ADDENDUM 01

Addendum to the drawings and specifications for:
Kendall County – Emergency Medical Services Station No. 3

EMERGENCY MEDICAL SERVICES STATION NO.3

10.06.23

1 ELECTRICAL POWER PLAN - ENLARGED MECHANICAL, ELECTRICAL AND DATA ROOMS
1/4" = 1'-0"

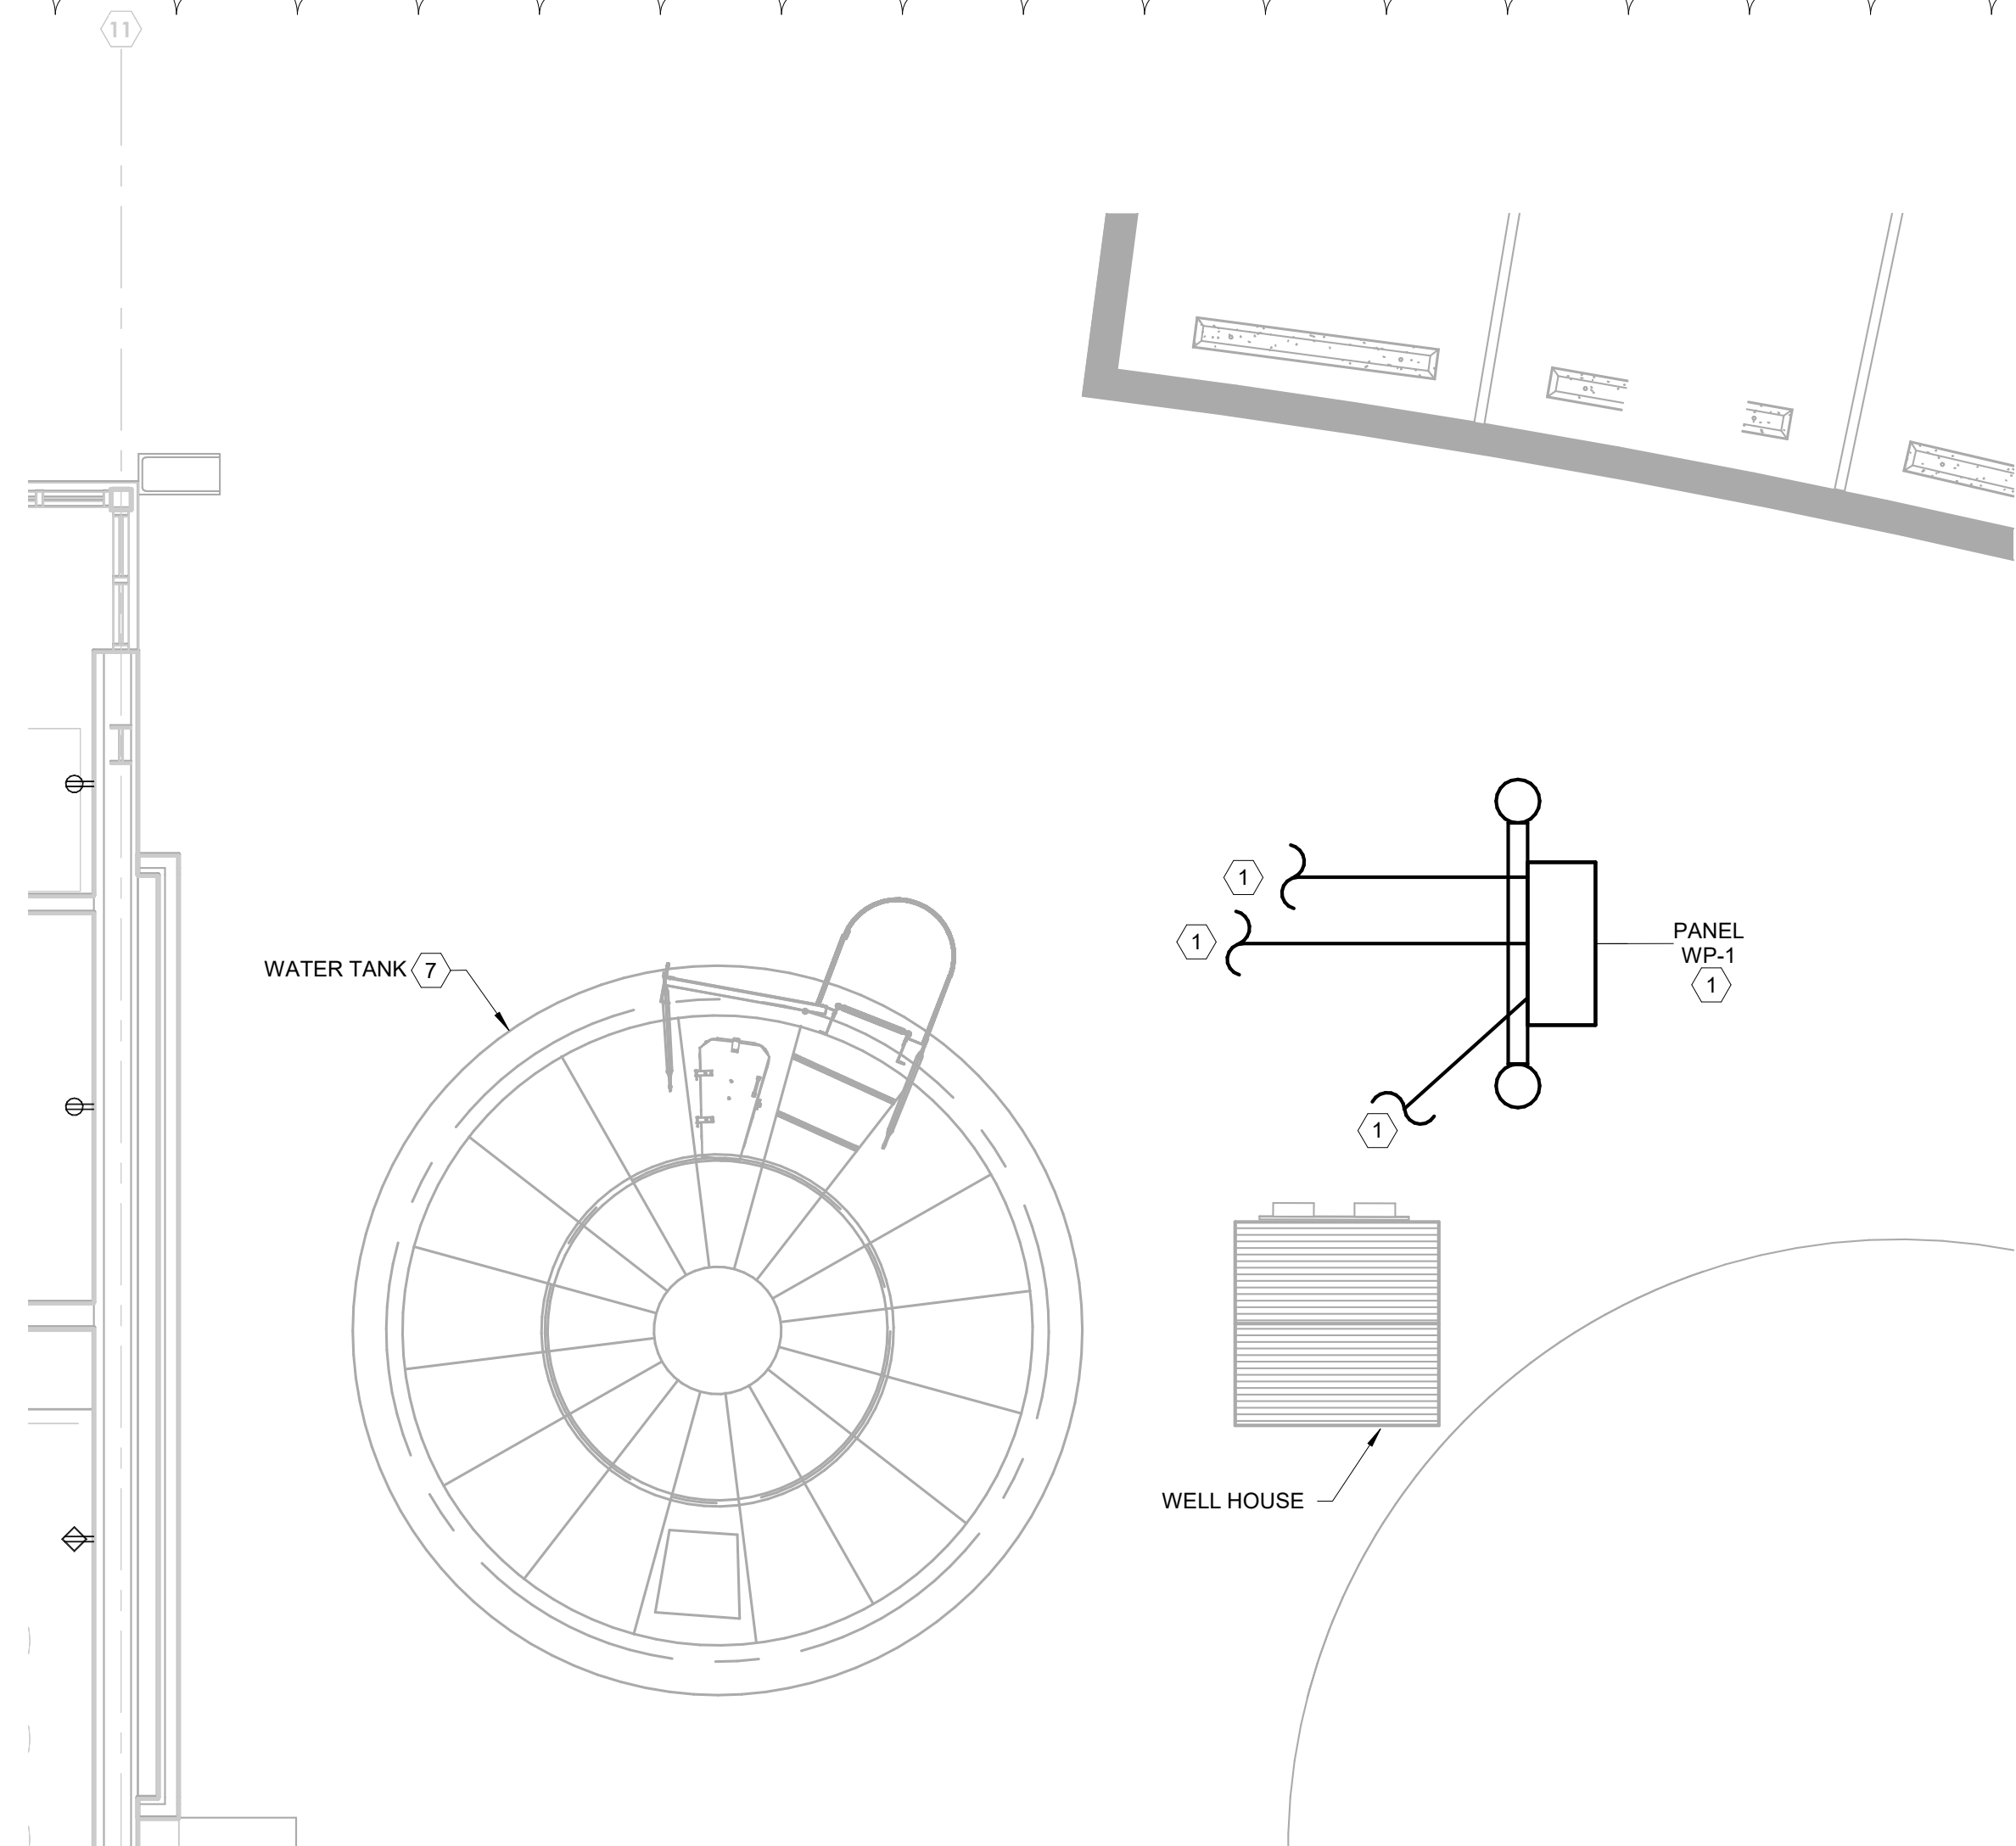
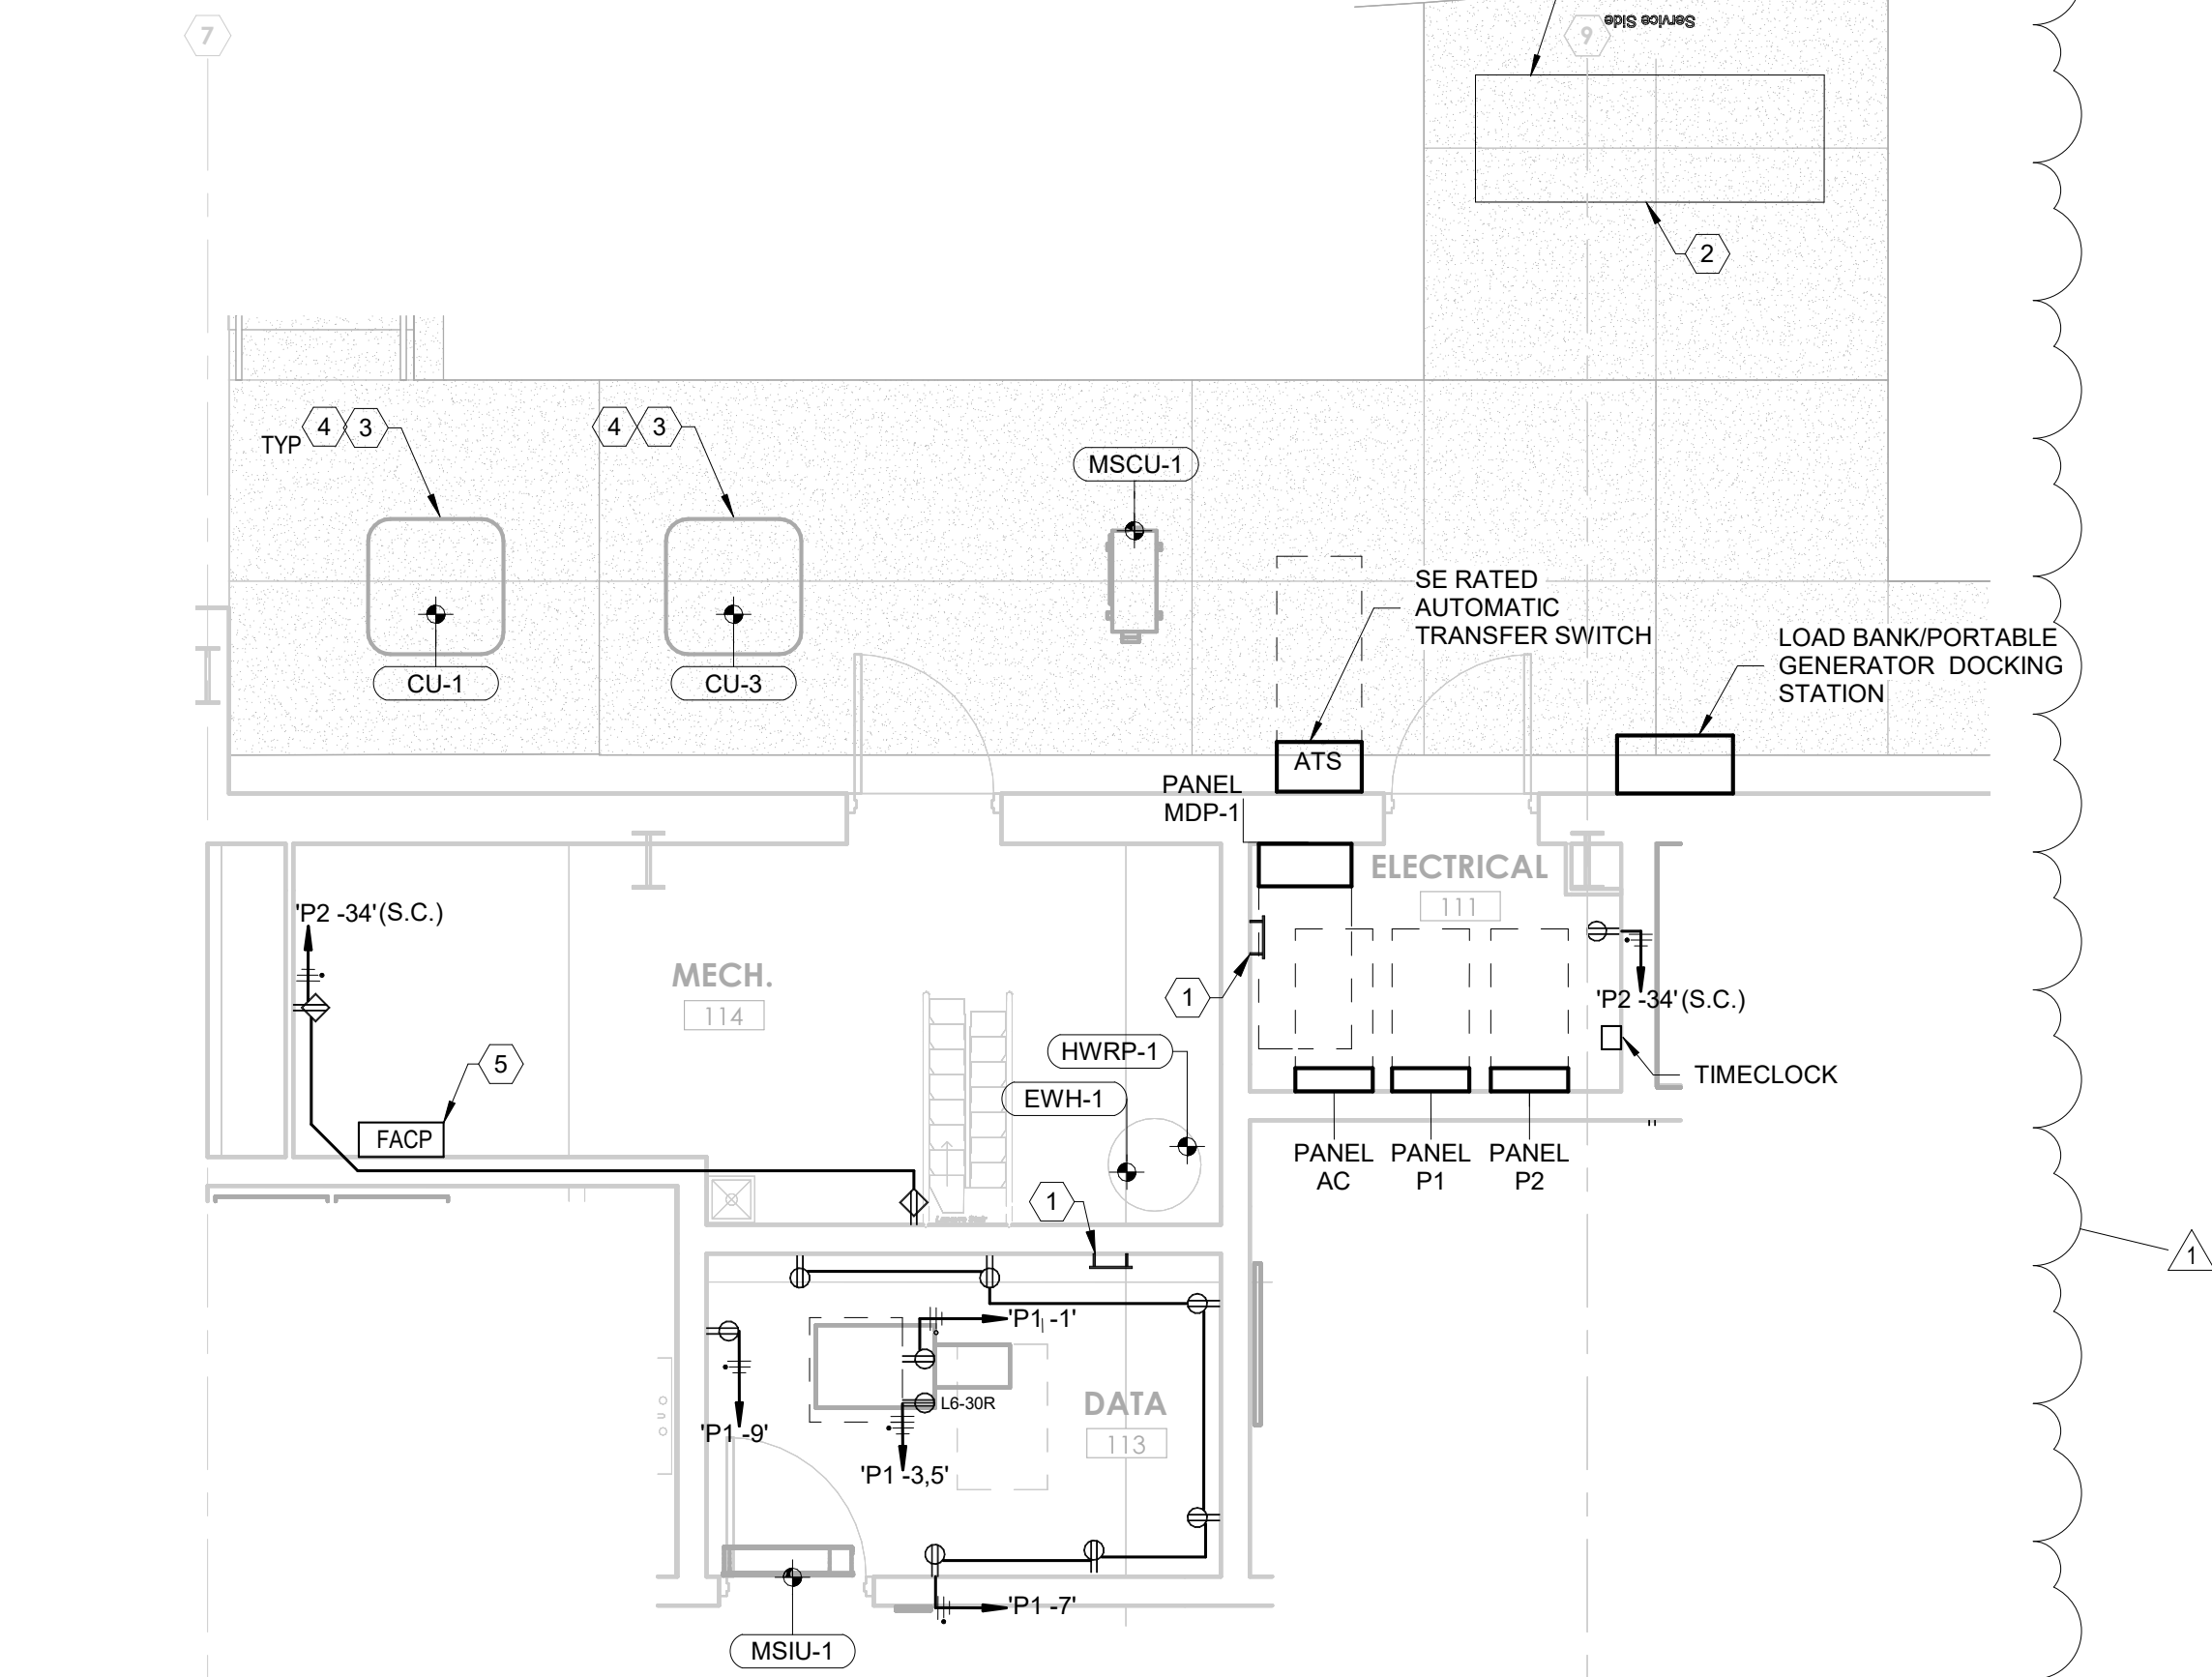
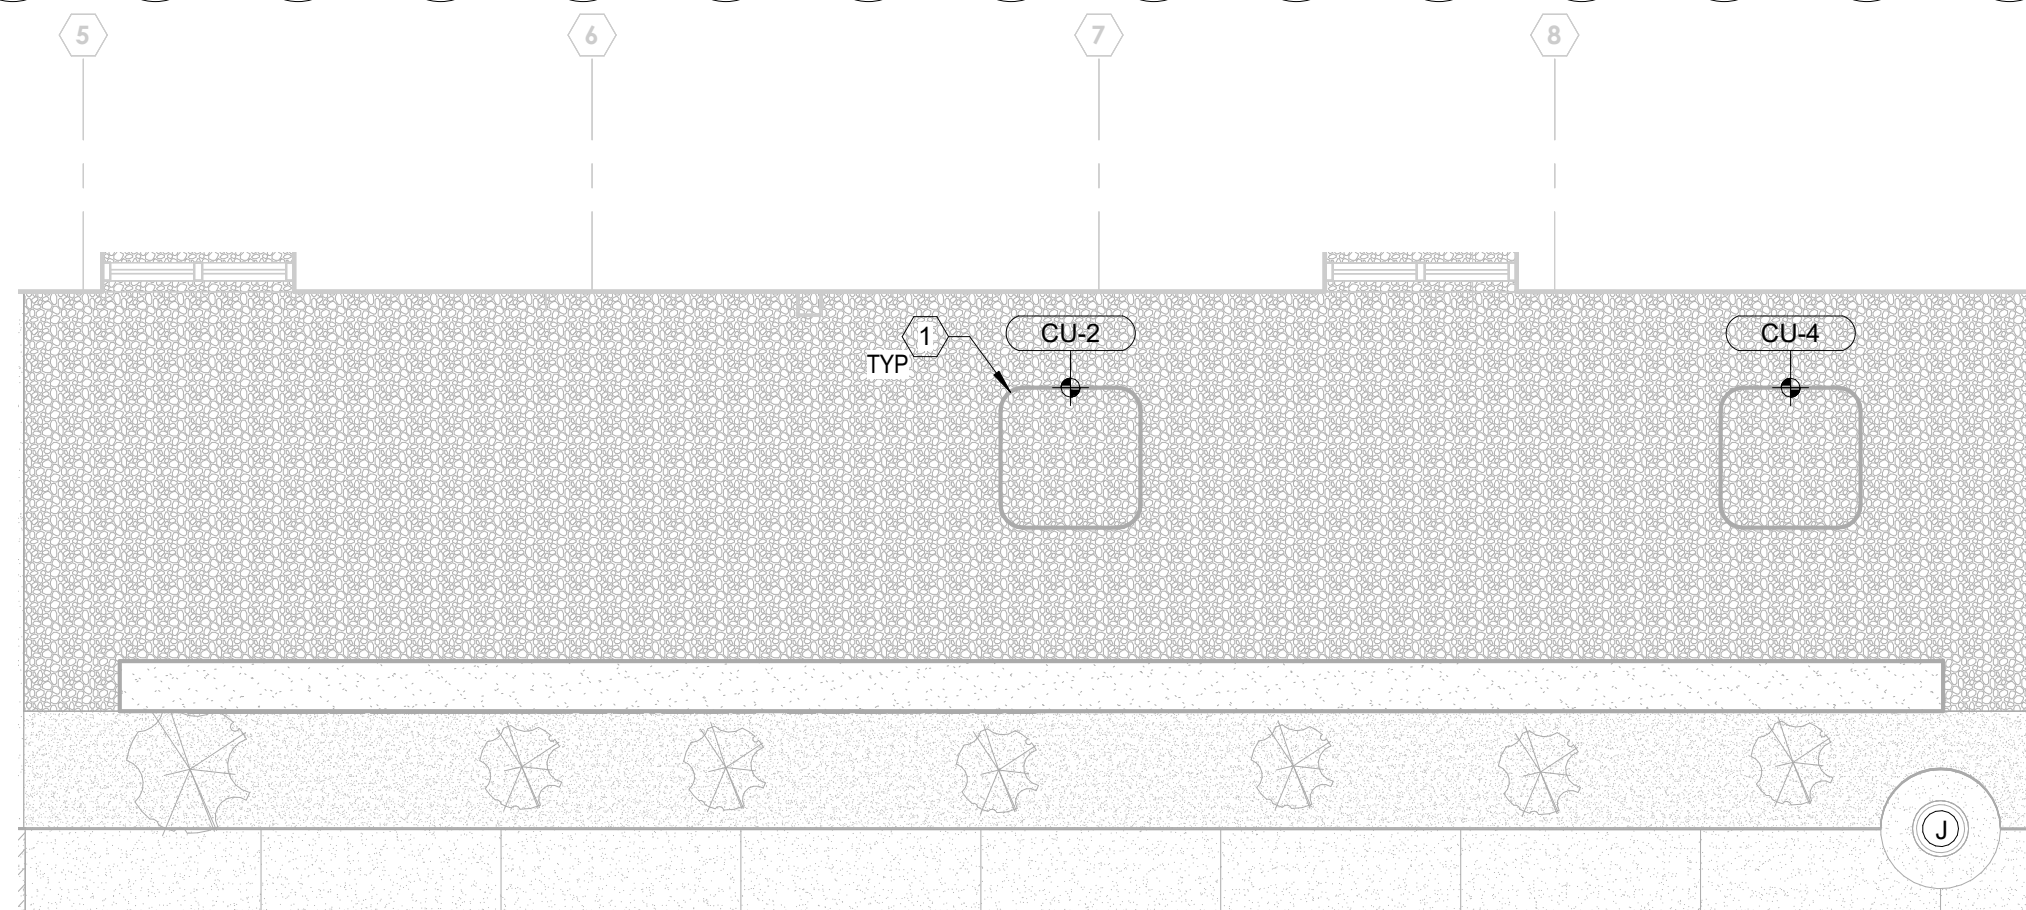
- Item 1: Added Detail 3 Electrical Site Plan – Enlarged Well plan.
- Item 2: Detail 1 – add FACP to mechanical room.
- Item 3: Relocated receptacle in Electrical room to avoid column.
- Item 4: Updated receptacles in Data Room to match Technology drawings.

- Item 1: Added Detail 3 Electrical Site Plan – Enlarged Well plan.
- Item 2: Detail 1 – add FACP to mechanical room.
- Item 3: Relocated receptacle in Electrical room to avoid column.
- Item 4: Updated receptacle locations in Data Room to match Technology drawings.
